MMC has eliminated the front air guide panels (LH/RH) on Lancers without "factory fitted Fog lamps".
When you install the "Accessory Fog lamp kit" for this vehicle (which did not come equipped the "Air guide panel,LH/RH"),
please get 2pcs of "Harness Clamp - MS470067 to hold the "Fog lamp harness" instead of "white resin harness clip" as shown below.
The following pictures show only the "LH side" of the grille. Please work the "RH side" as same manner.

Present situation and fixing procedure

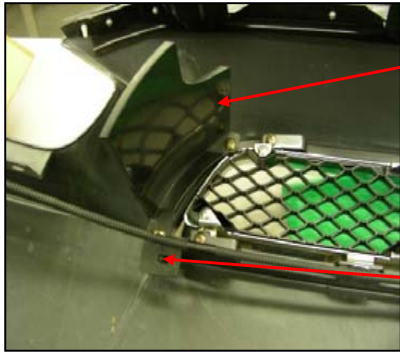
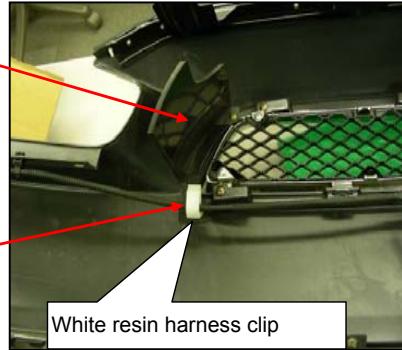
The "Air guide panel,LH/RH will be deleted.
So, it can not use the fixing point [*].

The fixing point [*]

White resin harness clip

Future situation and fixing procedure

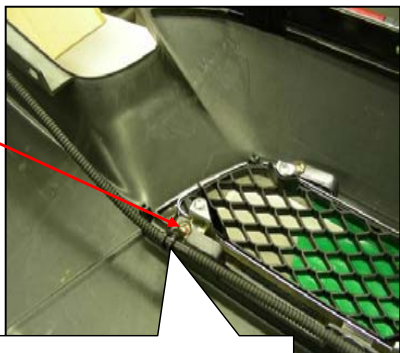
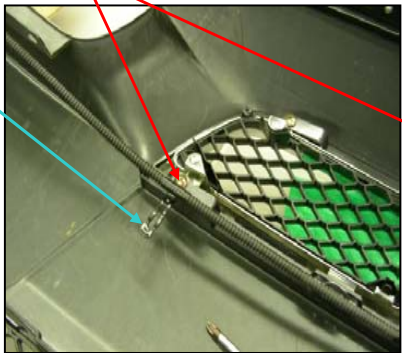
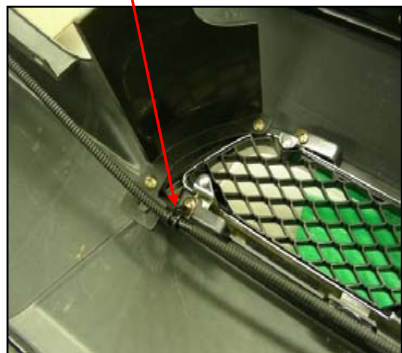
Please fix the "Harness clamp" together with the "screw for radiator grille."

It can be use for the current vehicles which equipped with "Air guide panel."

Harness Clamp
MS470067

Twist the "Harness clamp" and hold the fog lamp harness.
